## **Evaluation of the Tailings Dam, Cyanide Use and Water Consumption at the Proposed Volta Grande Gold Project, Pará, Northern Brazil**

Steven H. Emerman, Ph.D., Malach Consulting, LLC, 785 N 200 W, Spanish Fork, Utah 84660, USA, Tel: 1-801-921-1228, E-mail: SHEmerman@gmail.com

Report written at the request of Amazon Watch, submitted June 1, 2020

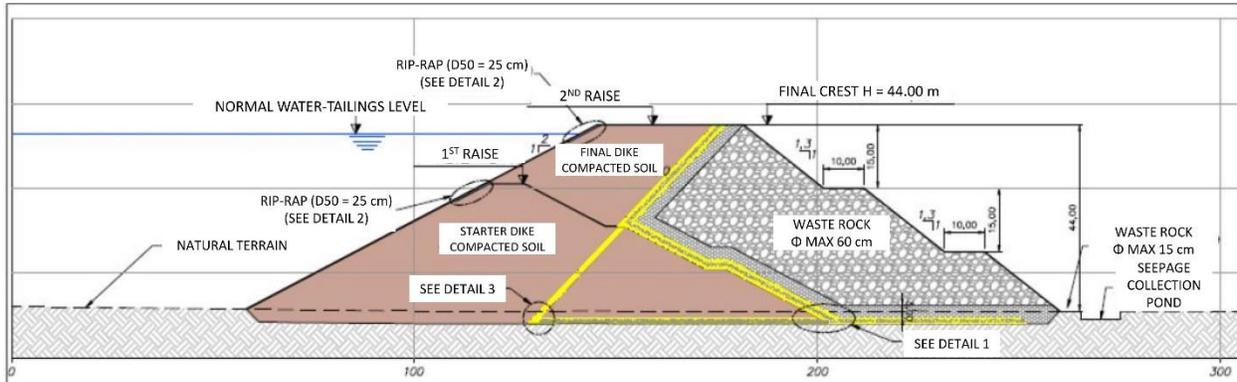
The tailings dam for the Volta Grande Project would be constructed in two stages using the downstream construction method (see Figs. 6b and 8). The starter dike would be constructed out of compacted soil from the project site to a height of 26.5 meters. The final dike would be constructed out of compacted soil on the upstream side and mine waste rock on the downstream side to a final height of 44 meters (see Fig. 8). Before export to the tailings pond, the cyanide would be destroyed using sulfur dioxide and the tailings would be thickened to a solids content of 53% by weight. The tailings dam would have zero downstream discharge in that all seepage from the dam would be pumped back into the tailings pond (Brandt Meio Ambiente, 2016a; VOGBR, 2016a).

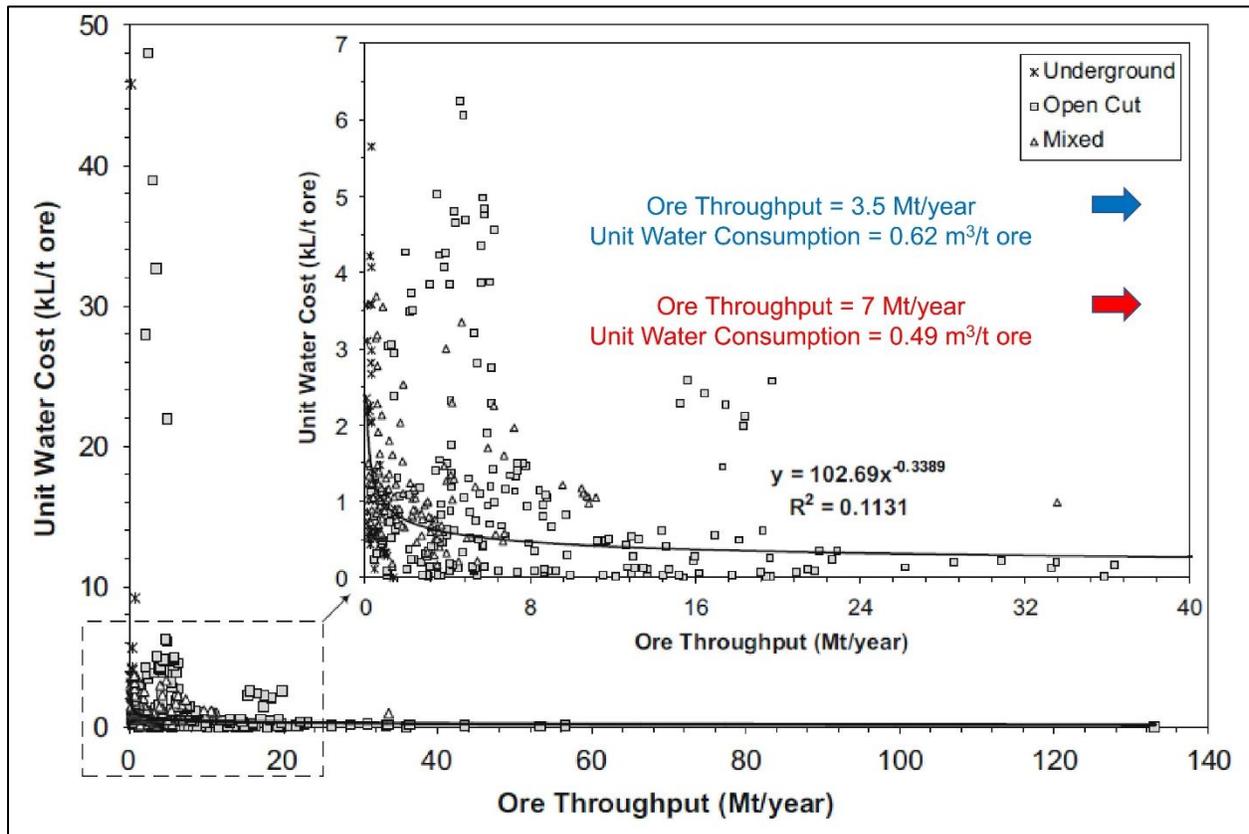
Based upon the predicted water consumption (261.9 cubic meters of water per hour), ore production rate (3.5 million metric tons per year) and grade (1.47 grams of gold per metric ton) for the Volta Grande Project, the per unit water consumption would be 0.655 cubic meters of water per metric ton of ore and 445,920 cubic meters of water per metric ton of gold (see Table 2). Although no document has presented a detailed water budget, the above predictions are fully consistent with gold mining industry trends (see Table 2). On the other hand, the predicted hourly water consumption, ore production rate and average grade of the earlier Feasibility Report (Chubb et al., 2015) would have predicted unit water consumptions of 0.200 cubic meters of

water per metric ton of ore and 128,350 cubic meters of water per metric ton of gold for Phase I, and 0.163 cubic meters of water per metric ton of ore and 167,720 cubic meters of water per metric ton of gold for Phase II (see Table 2). The earlier predictions would have been much less than is typical for the gold mining industry and were not accompanied by any explanation as to how such high water efficiency would be achieved. Thus, a more realistic understanding of water efficiency seems to have occurred between the 2015 Feasibility Study (Chubb et al., 2015) and the 2016 EIS (Brandt Meio Ambiente, 2016a).

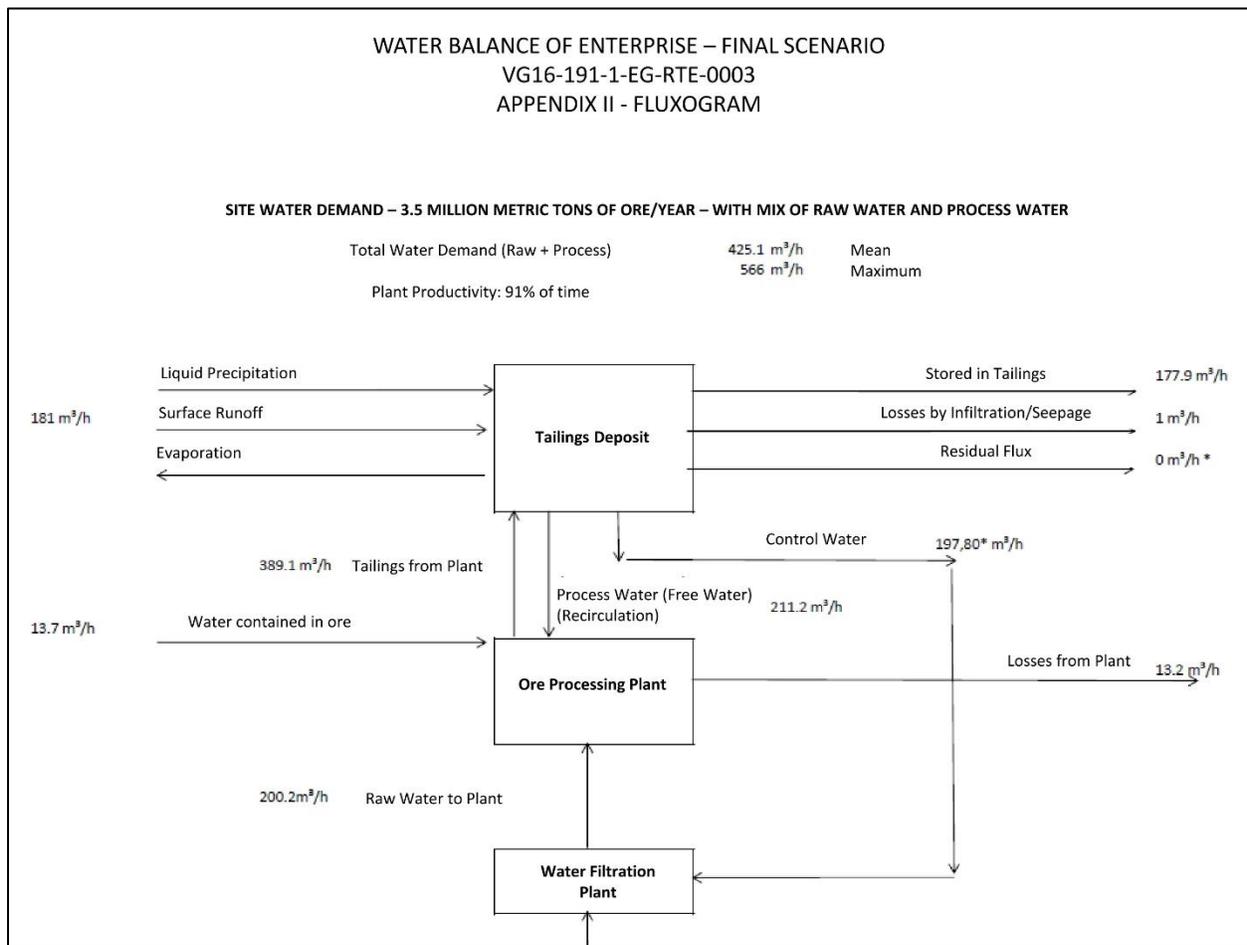
Although the predicted water consumption of the Volta Grande Project seems perfectly reasonable, it is important to consider how the water economy is achieved. The tailings deposit will receive both water (the spent cyanide leach) from the ore processing plant and the surface runoff from the watershed (see Figs. 3 and 10). Out of the free water that accumulates in the tailings deposit, 211.2 cubic meters of water per hour would be pumped back into the ore processing plant without water treatment and 197.8 cubic meters of water per hour would be pumped through a water filtration plant for removal of sediment before pumping to the ore processing plant (VOGBR, 2016b; see Fig. 10). The result of the use of the tailings deposit as, essentially, a water storage pond, is that there would always be free water on top of the tailings (see Fig. 11a) with 7 meters of free water by the end of the mining operation (see Fig. 11b). As a consequence, almost all of the tailings would be saturated with water (see Fig. 12a). Out of the 35.43 million cubic meters of tailings and water that would remain at the end of the mining operation, 32.36 million cubic meters would be saturated tailings, while 3.07 million cubic meters would be free water on top of the tailings (Brandt Meio Ambiente, 2016b).

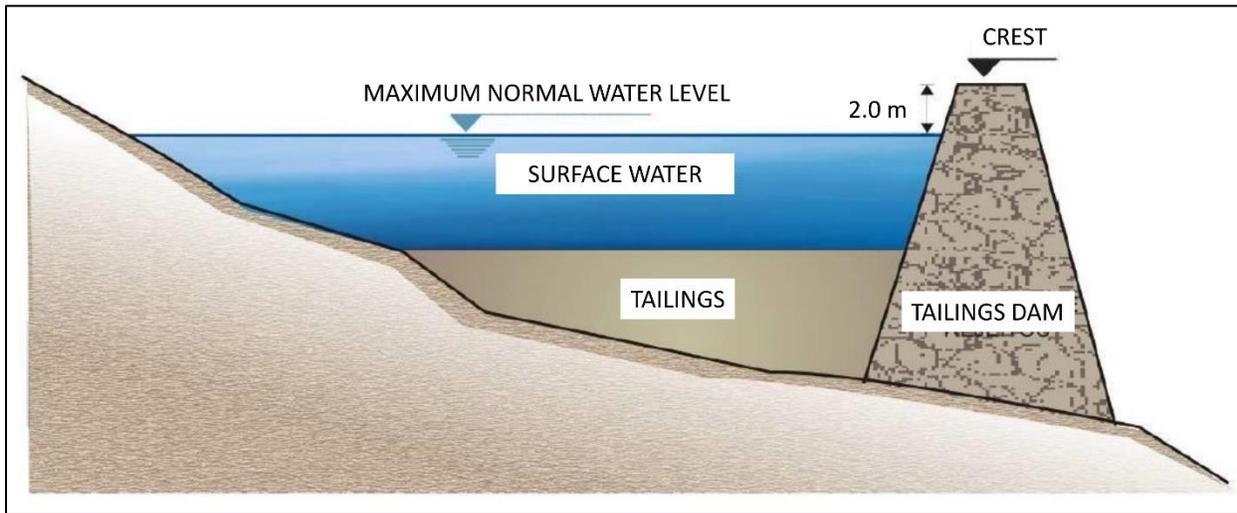
The use of the tailings deposit to capture surface runoff is a very unusual practice at the present time. In fact, it is far more common to construct a system of diversion channels to prevent the entry of catchment water into the tailings deposit in order to reduce the water content of the tailings (Vick, 1990). The mining company does plan to thicken the mixture of tailings and water to a 53% solids content before export to the tailings deposit. However, the addition of 181 cubic meters of water (surface runoff + precipitation – evaporation) for every 389.1 cubic meters of water from the ore processing plant (see Fig. 10) would give the mixture of tailings and water an effective solids content of 43%, which is within the range for conventional tailings management with no thickening.

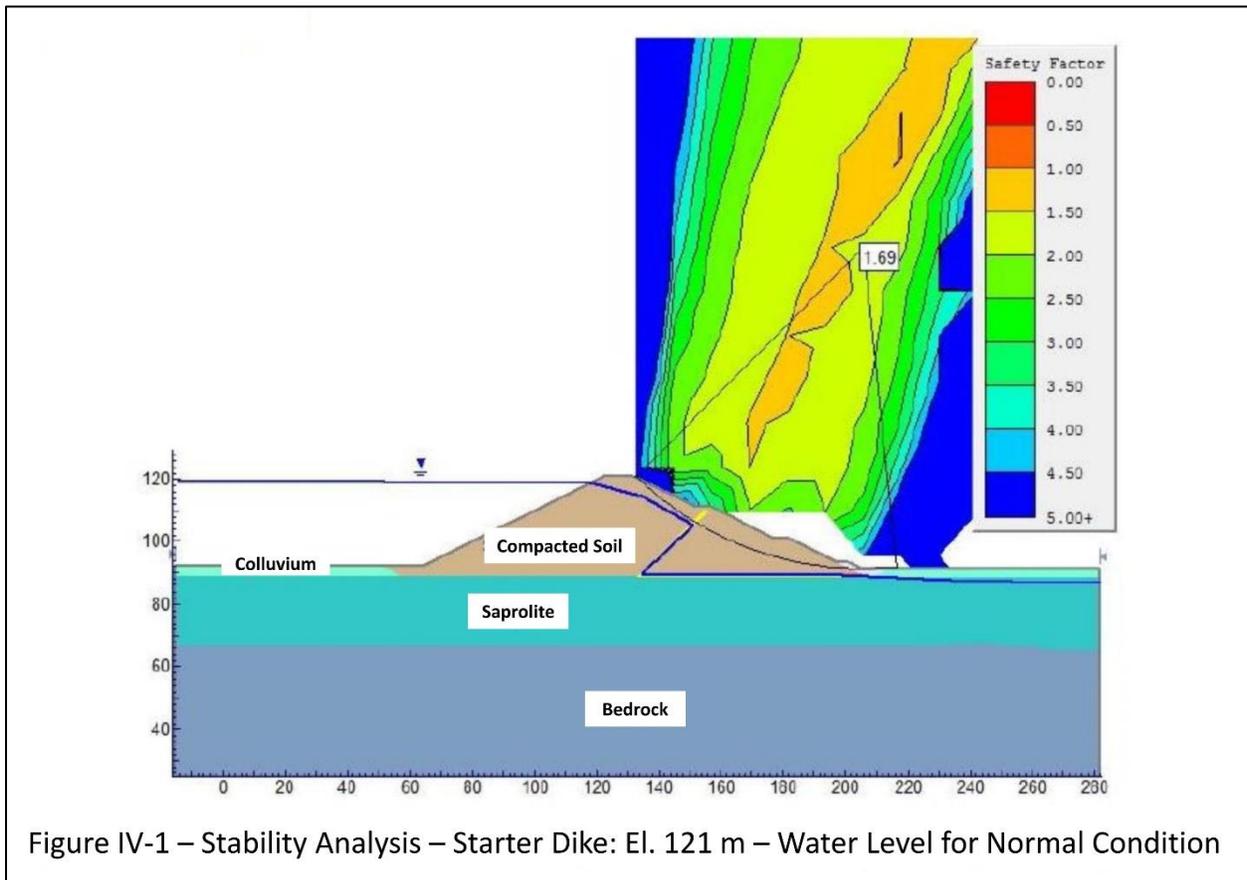
Based upon the geometry of the tailings deposit, an assumed water table height, and the geotechnical parameters of the compacted soil and the foundation, the starter dike would have a factor of safety of 1.69 against failure by slumping or sliding (see Fig. 12a), which is reasonably greater than the minimum value (1.50) required by Brazilian tailings dam regulations (ABNT, 2017). The internal drainage system (yellow lines in Figs. 8 and 12a) would clearly play a critical

role in lowering the water table within the tailings dam (although not in the tailings stored behind the dam). Any failure of the internal drainage system that would allow the water table to rise about one-half the dam height on the downslope side of the starter dike would cause the factor of safety to drop below the minimum acceptable value (see Fig. 12b). I have not seen any document that carries out the same stability analysis for the final dike.

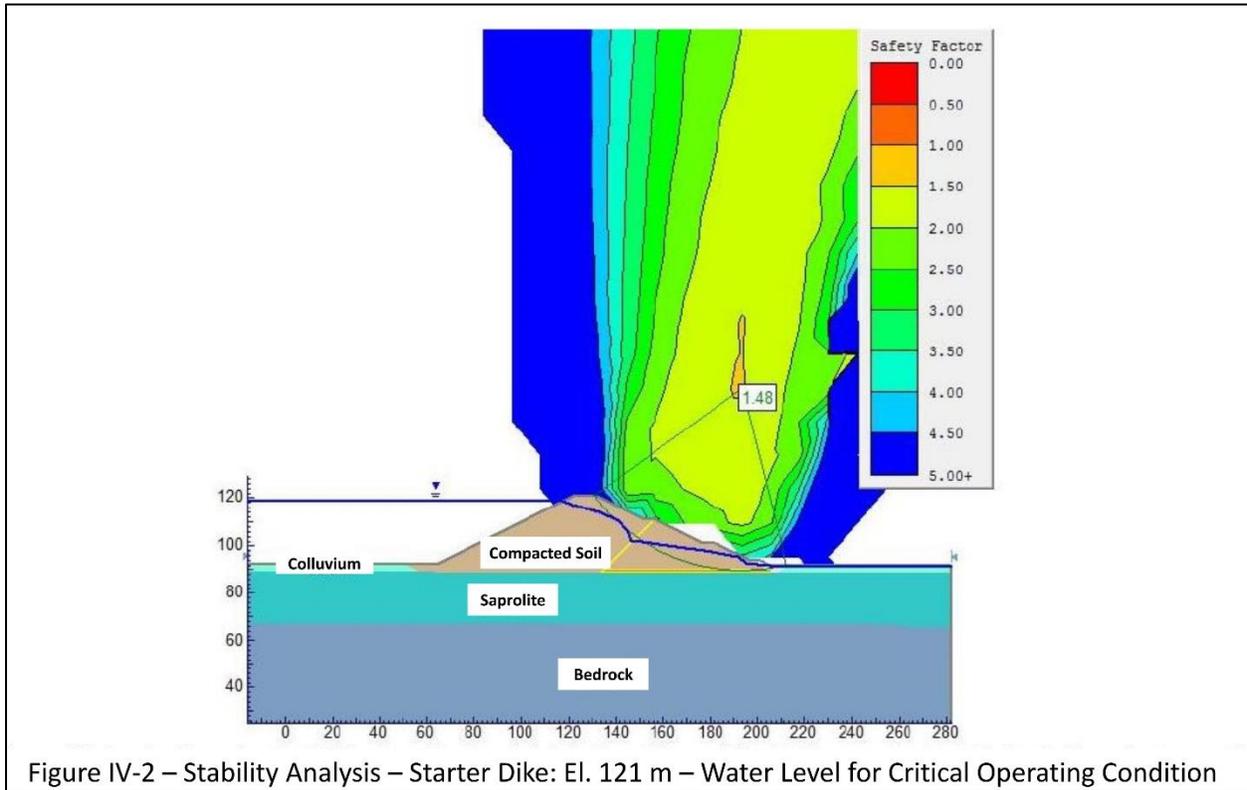
It is most disturbing that the existing stability analyses were carried out only under static conditions and not under the condition of a design seismic acceleration. In fact, none of the documents of the 2016 EIS discuss a design earthquake or include any analysis of local or regional seismicity. This is surprising because the documents show maps of faults and fractures in the vicinity of the mining project site, including three possible faults intersecting at the exact site of the proposed tailings dam (see Figs. 13a-b; VOGBR, 2016a). However, these faults were discussed only in terms of their ability to transmit seepage of water from the tailings deposit, and not in terms of their ability to act as sources of seismicity.

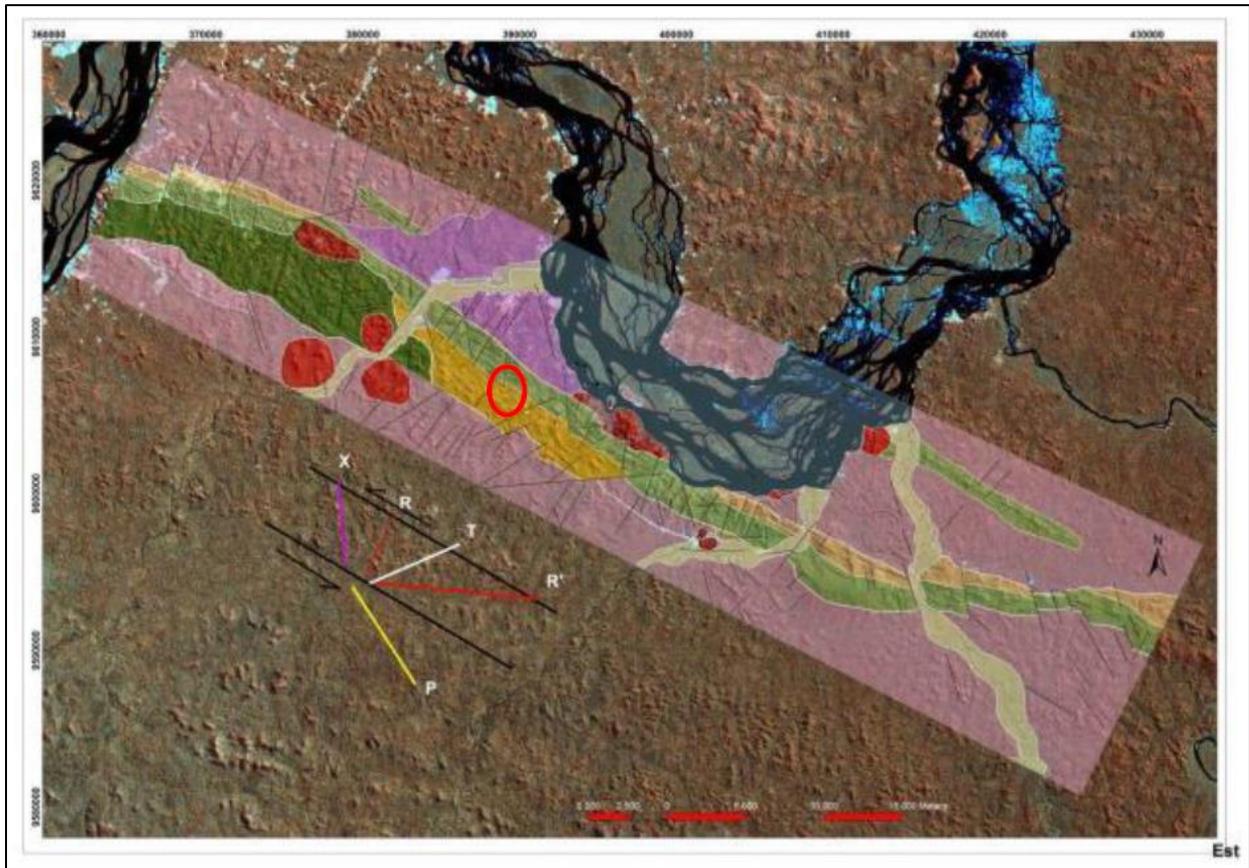
As mentioned earlier, this failure to carry out seismic studies and to design a tailings dam to accommodate the Maximum Credible Earthquake (MCE) is in violation of current Brazilian tailings dam regulations (ABNT, 2017). It is disturbing that, in a presentation to FUNAI

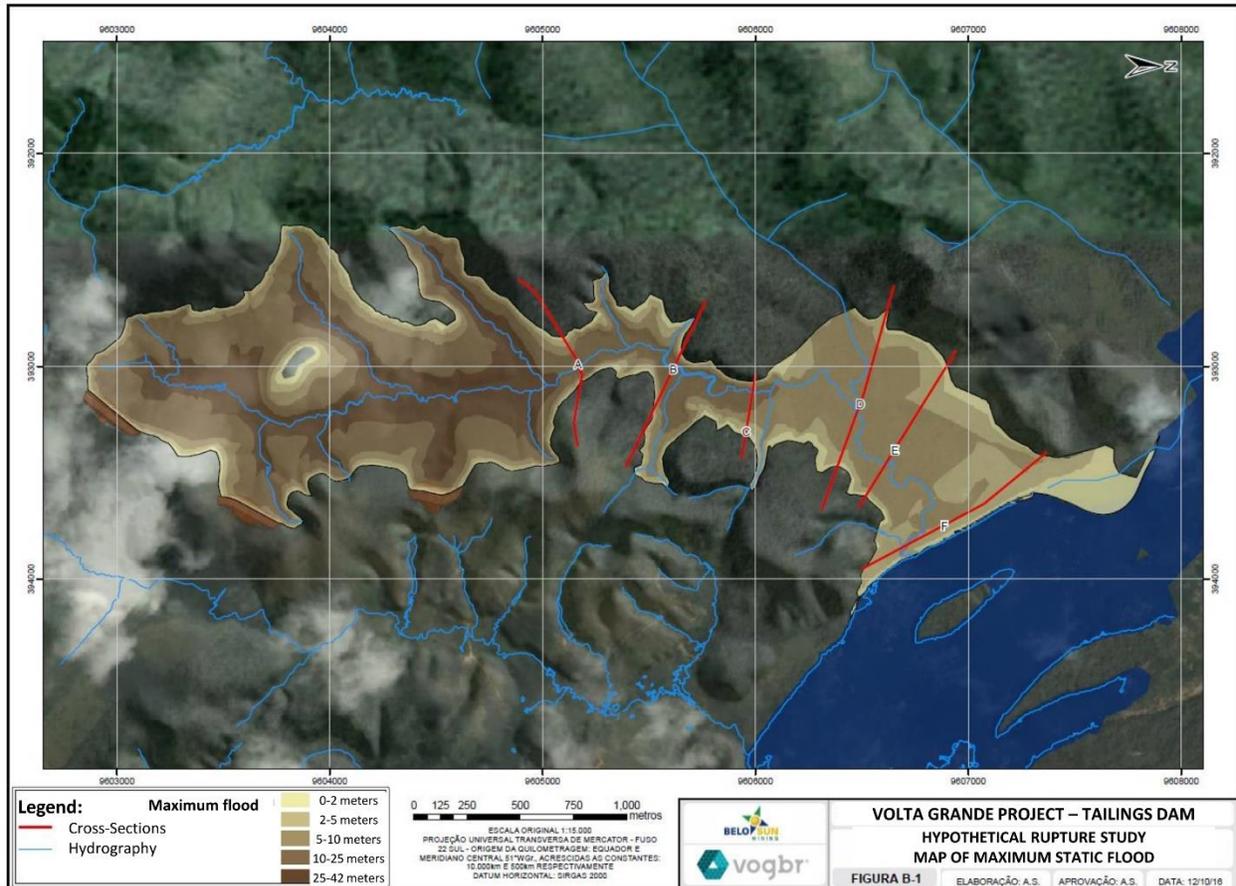
It is difficult to reconcile the above results with the conclusions reached by Brandt Meio Ambiente (2016a). According to the 2016 EIS, the tailings flood would reach the banks of the Xingu River in 97 minutes, corresponding to a tailings flow velocity of 1.4 kilometers per hour. The above velocity is quite slow. The vast majority of streams at flood stage have velocities in the range 4-11 kilometers per hour (Leopold, 1994). No available document has explained the details of the calculation. However, a hint is given in Brandt Meio Ambiente (2016a), which lists as one of the assumptions of the calculation “*Critério de parada: atingir o Rio Xingu* [Stopping criterion: Reaching the Xingu River] (see Fig. 14). There is no physical basis for the assumption that the tailings would come to a stop upon reaching the Xingu River, especially not a river with a minimum discharge of 700 cubic meters per second (Higgins, 2020).
